**PVNGS Unit 1 Operating License Page 4**  
**Retyped with Proposed Power Uprate Changes**

**PVNGS Unit 3 Operating License Page 4**  
**Retyped with Proposed Power Uprate Changes**

Figure 3.4.1-1, (Page 1 of 2)  
Reactor Coolant Cold Leg Temperature vs. Core Power Level

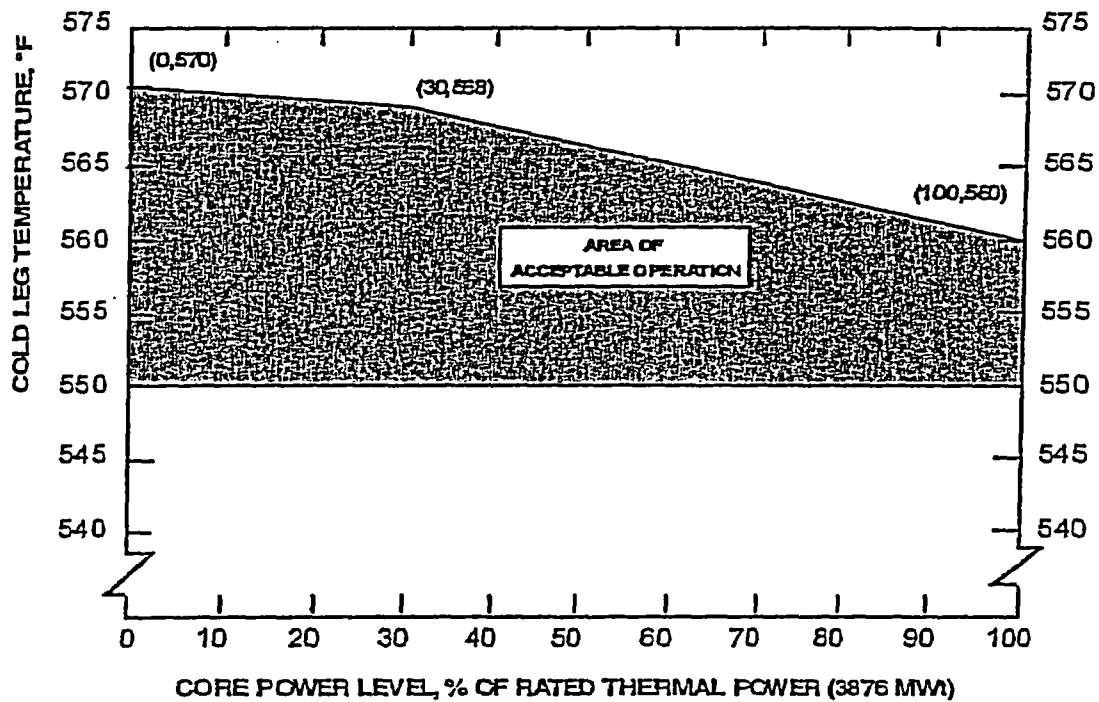
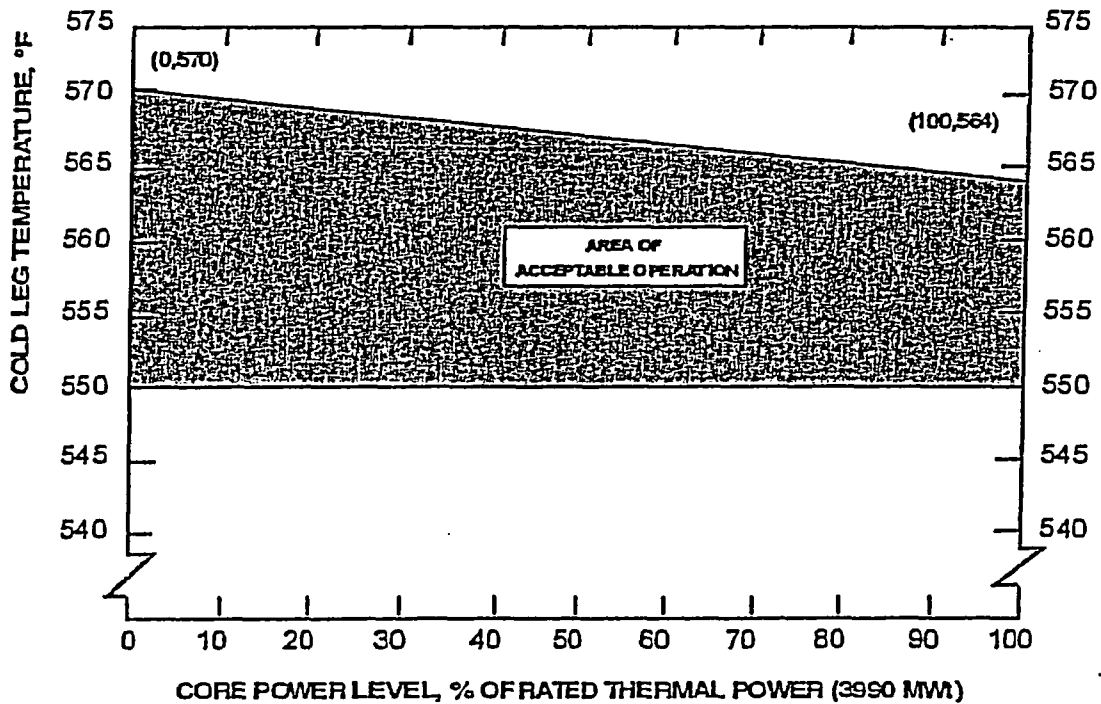
3876 MWt RTP

3990 MWt RTP
